GFA AD 542
(ISSUE 1)

TYPE AFFECTED: SZD-50-3 Puchacz

SUBJECT: Replacement of wing-to-fuselage front fitting

MANDATORY BULLETIN No BE-049/SZD-50-3/2000 „PUCHACZ”

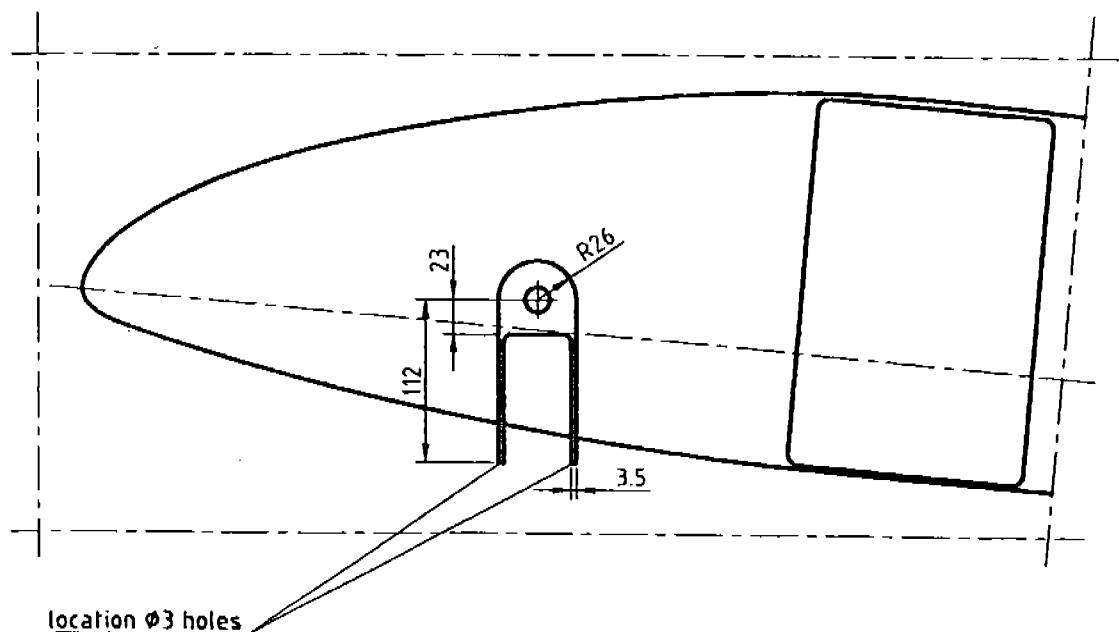
Front fitting replacement must be made on each plane of SZD-50-3 "PUCHACZ" model on which, in inspection, a crack of length exceeding 3 mm has been found.

- Make a cut-out in fuselage skin, in accordance with following drawing.

To facilitate marking of cut-out contour, make a hole with 3 mm diameter drill in fuselage skin from inside, close to bulkhead.
